| Flight Procedures Cover Page | Task Action: FLIGHT CHECK | Task Type: IAP | Estimated Chart Date: 03/19/2026 | APWS Task ID: E552A1041C7C45DB85DA07C3A77875AC | APWS Project ID: 38C4D3376A724C3987525CC2789303D7 |
| Procedure: ILS OR LOC RWY 35R AMDT 4 | | Enroute: NO | Specialist: Purnell, Troy | | Agreement Number: |
| Airport ID: KDEN | | | Airport City: DENVER | | State: CO |

AMEND MISSED APPROACH. REMOVE REFERENCES TO DEN VOR FOR FUTURE DEN VOR DECOM. AFS REQUIRED.

ILS or LOC RWY 35R

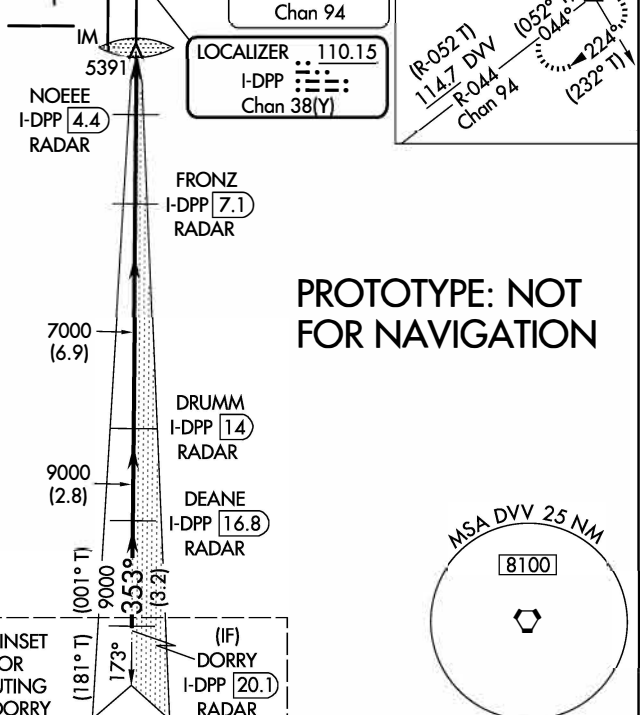
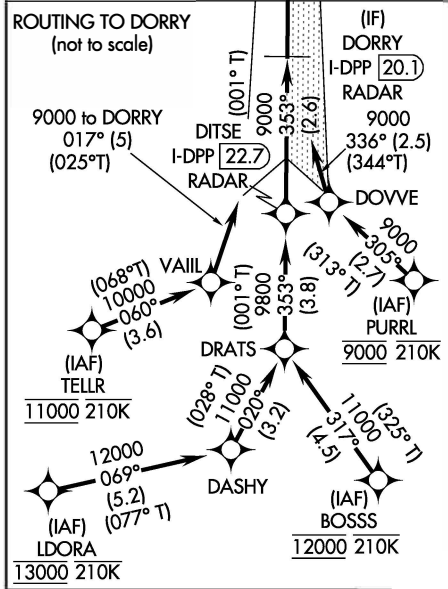
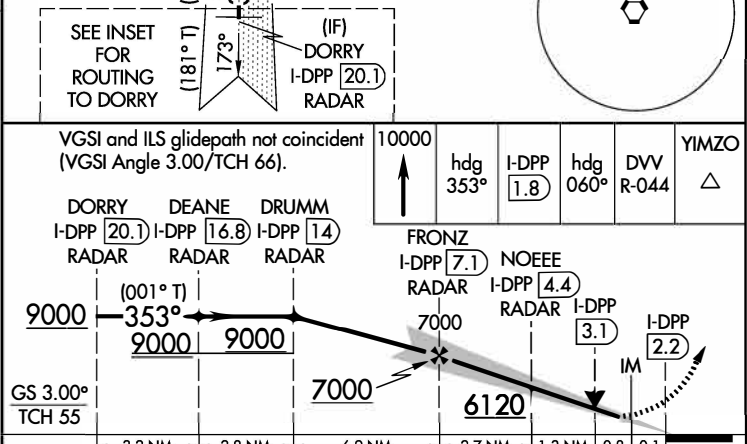
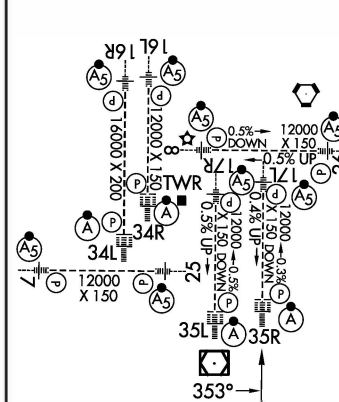
1. MISSED APPROACH: CHANGED MISSED APPROACH FROM "CLIMB TO 5900 THEN CLIMBING RIGHT TURN TO 10000 ON HEADING 038 AND ON DVV VORTAC R-044 TO YIMZO/DVV 21.67 DME/RADAR AND HOLD. TO "CLIMB TO 10000 ON HEADING 353 TO I-DPP 1.80 DME NORTH OF I-DPP AND ON HEADING 060 AND ON DVV R-044 TO YIMZO INT/DVV 21.67 DME AND HOLD."
2. TERMINAL ROUTES: REMOVED "TF, FB, 1.00" FROM LEG DITSE/I-DPP 22.69 DME/RADAR - DORRY/I-DPP 20.07 DME/RADAR, AND ADDED (I-DPP) TO COURSE.
3. CHANGED NOTE SPELLING FROM "FOR INOPERATIVE ALS..." TO "FOR INOPERATIVE ALS..."

1. CHANGED MISSED APPROACH FROM "CLIMB TO 10000 ON HEADING 353 TO I-DPP 1.80 DME NORTH OF I-DPP AND ON HEADING 060 AND ON DVV R-044 TO YIMZO INT/DVV 21.67 DME AND HOLD" TO "CLIMB TO 10000 ON HEADING 353 TO 1.80 DME NORTH OF I-DPP AND CONTINUE CLIMB ON HEADING 060 TO DVV VORTAC R-044 TO YIMZO INT/DVV 21.67 DME AND HOLD."
2. ADDED "CHART IN PROFILE I-DPP DME ANTENNA" TO ADDITIONAL FLIGHT DATA.

ALSIF-2 MISSED APPROACH: CLIMB TO 10000 ON HEADING 353 TO 1.8 DME NORTH OF I-DPP AND CONTINUE CLIMB ON HEADING 060 TO DVV VORTAC R-044 TO YIMZO INT/ DVV 21.7 DME AND HOLD.
